13 May 2011

**Report on the Proposed Residential Subdivision
at Catherine Hill Bay by Coastal Hamlets Pty Ltd**

7.1 Stage 3

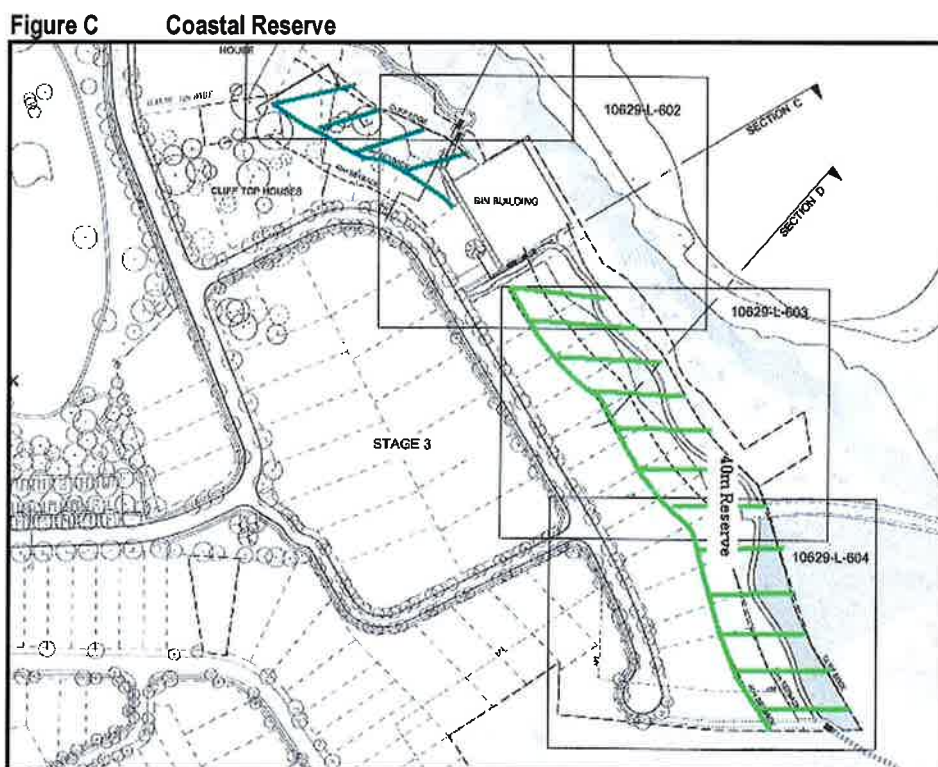
The proposed coastal reserve and walkway is a significant public benefit of the proposal. The IHAP recommended a 25m coastal reserve from the cliff line. In response to public submissions, the Department recommended a 40m coastal reserve as well as a perimeter road to be provided adjacent to the reserve for easy public access.

The Commission supports a 40m coastal set back from the cliff line south of the Bin Building. To the north of the Bin Building, the coastal reserve should be 25m from the cliff line as the coastal walk would be below the cliff line. However, the set back is required for visual impact and safety reasons. (see Figure C)

The Commission questioned the need for the perimeter road, particularly when the coastal reserve is increased from 25m to 40m. If the extra 15m reserve is well vegetated, it could provide a very substantial boundary between public and private properties as well as protecting the scenic quality of the coast. With a well designed public area in the Bin

- (j) Stage 3 of the development is to be redesigned to provide for a coastal reserve including the coastal walk. The reserve must be 40m from the cliff line south of the Bin Building and 25m from the cliff line north of the Bin Building. The cliff line is defined as the line that represents the point where the land at the cliff edge has a slope of 20%. Private property must not encroach onto the reserve.
